SUBURBAN TOYOTA SERVICE CENTER JSP18-15

MOTION SHEET

PLAN REVIEW CENTER REPORT

PLAN REVIEW CENTER REPORT

Figure 1. City of Novi Regulated Wetland & Woodland Map (approximate parcel boundary shown in red). Regulated Woodland areas are shown in green and Regulated Wetland areas are shown in blue.

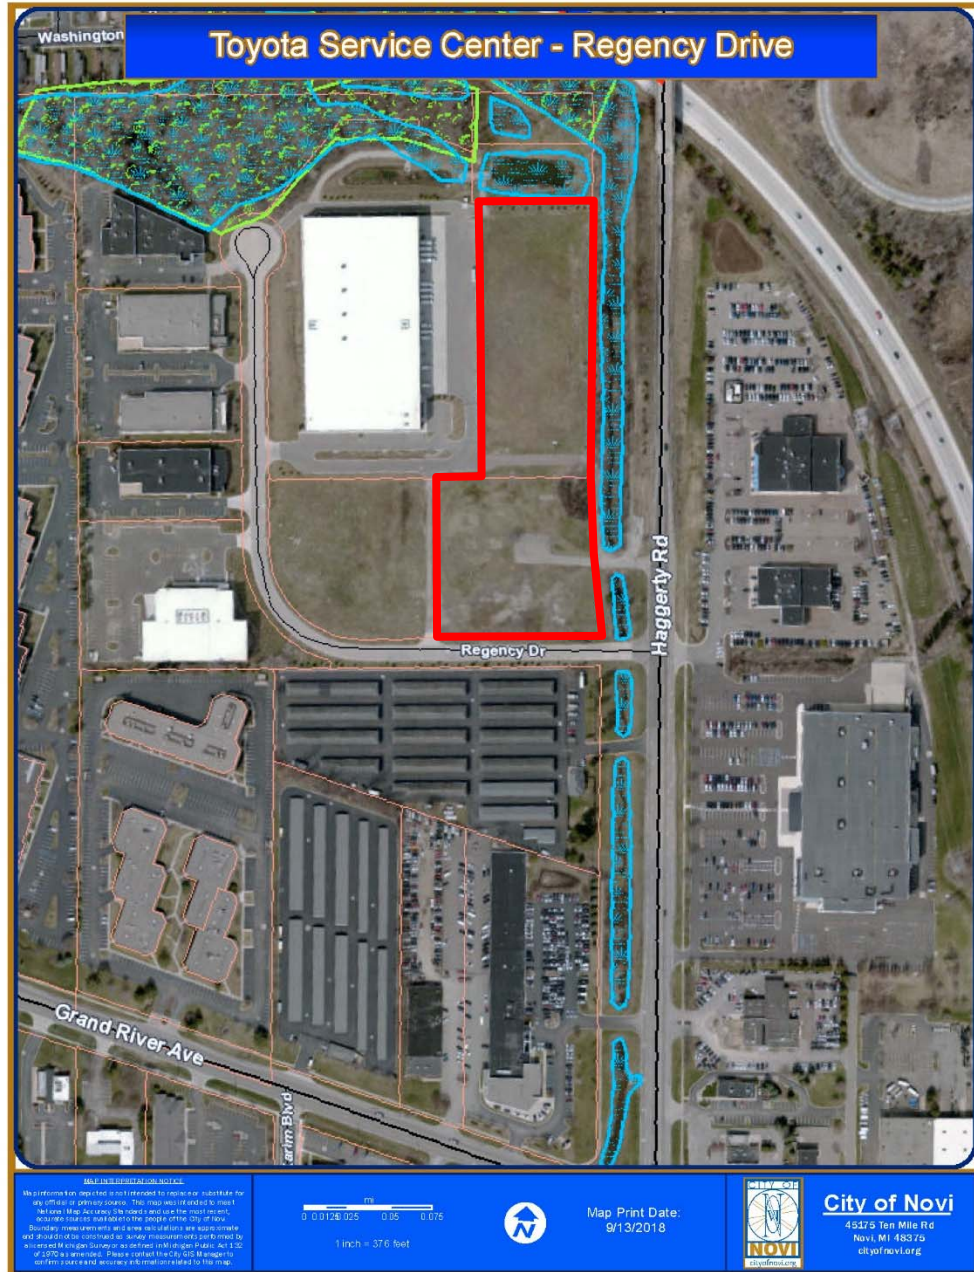
ECT conducted an on-site inspection and wetland/watercourse evaluation for the proposed project on August 29, 2018. ECT's in-office review of available materials included the City of Novi Regulated Wetland and Watercourse map (see Figure 1), USGS topographic quadrangle map, NRCS soils map, USFWS National Wetland Inventory map, and historical aerial photographs (from Oakland County). Based on our review of this information the overall proposed project parcel contains areas mapped as City-Regulated Wetlands/Watercourses. Specifically, Ingersoll Creek (Townline Drain) is located immediately adjacent to the east of the project. Wetland/watercourse boundary flagging was not apparent at the time of our inspection, however, based on the existing topography it is ECT's assessment that the on-site watercourse has been accurately indicated on the Plan.
